Contract #: 04-0120F4Cty: SF/ALA Rte: 80 PM: 13.2/13.9File #: 69.25B**QUALITY ASSURANCE -- NON-CONFORMANCE REPORT****Location:** Changxing Island, Shanghai, P. R. China**Report No:** NCR-000489**Prime Contractor:** American Bridge/Fluor Enterprises, a JV**Date:** 23-Oct-2009**Submitting Contractor:** Zhenhua Port Machinery Company, Ltd (ZPMC), Changxing Island**NCR #:** ZPMC-0462**Type of problem:**

Reference Description: Missed MT indication by QC on Segment 7BE floorbeam flange**Description of Non-Conformance:**

Job Name: SAS Superstructure

Subject: NCR No. ZPMC-0462

Draft of Welding Discontinuity:

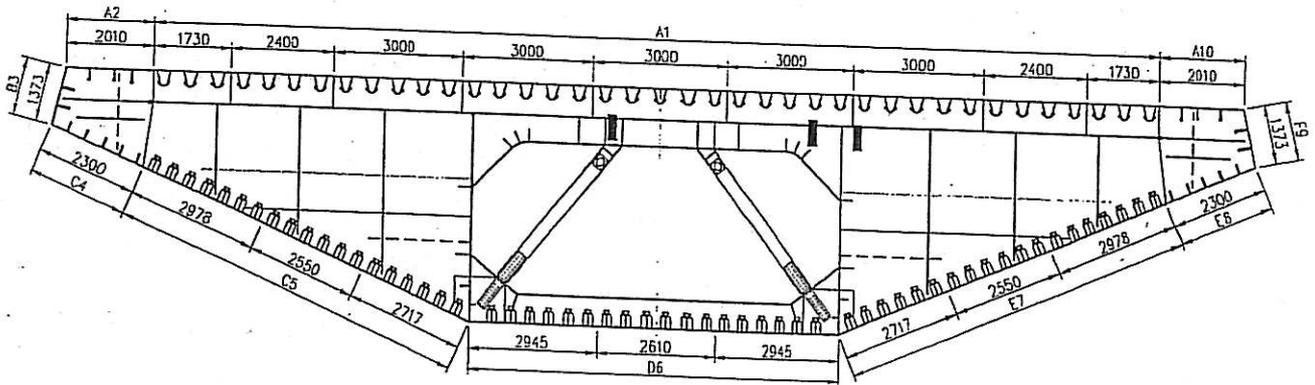
在对SSD18A-PP052-004检测时,发现1处横向裂纹。1、L1=15mm Y1=8950mm.

One transverse crack was found by use of MT on SSD18A-PP052-004

1. 火焰加热时, 水汽没有完全的去掉或者这个区域预热不够;
1. Moisture wasn't completely removed during drying the area wasn't preheated sufficiently.

1. QC and a Lead CWI shall be present, direct and supervise all grinding and welding operations during this repair to ensure the repair is per the disposition requirements.

2. QC and a Lead CWI shall have an approved copy of the CWR in hand prior to the repair.
3. Remove paint ≥ 25 mm in all direction of HAZ prior to MT.
4. Clean the excavation area of all loose debris including MT powder and UT gel. Remove cracks by grinding, repair area shall extend a minimum of 50mm beyond each end of single crack repairs, and 50mm beyond the outermost cracks for multiple crack repairs.

5. If base metal is damaged by grinding, the damaged area shall be ground clean prior to performing weld repair. If gap > 5 mm is found during or after grinding, comply with the notification on changing fillet weld to CJP which is submitted for Engineer's review and approval form.

6. Prepare excavation in accordance with the New Repair Procedure prior to welding.
7. Before this repair, Verify with VT and MT repair areas are defects free, and also MT shall be performed on the base metal laying abroad cracks to ensure that no cracks were propagated to the base metal. Separate CWR approval is needed if cracks are found in the base metal, and only after this new CWR's approval can continue the repair.

8. Clean excavation area of all loose debris including MT powder after excavation. Preheat and weld according to the Table 1 of the New Repair Procedure.

9. Perform post weld heating according to the Table 1 of the New Repair Procedure.
10. Allow the weld to cool to ambient temperature gradually. (SLOWLY COOL DOWN)

11. Grind the repaired area flush with base metal or the adjacent weld after post weld heating.
12. Wait 48 hours after the repair area has cooled to ambient temperature before performing NDT.

13. Perform MT inspection to all repair area according to Contract Drawings along with all additional NDT required by the applicable notes Special Provision Section 10-1.59 'Steel Structure', subsection 'inspection testing'.
